05T/06T Oil Solenoid Sightglass Accessory

Introducing a new oil solenoid sightglass accessory of our 05T/06T screw compressors, available July 6, 1999.

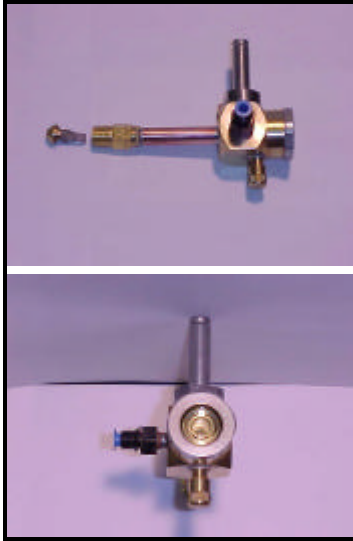
The EF23ZZ025 accessory is installed at the oil inlet connection of these screw compressors. The solenoid portion is wired into the compressor's electronic control module that opens the solenoid when the compressor is energized and closes when the compressor is de-energized. The solenoid valve port is sized to avoid excessive pressure drops with the oil approved with this compressor. The addition of the sightglass offers a useful feature to help field personnel verify oil is flowing when required and not leaking through when the compressor is off.
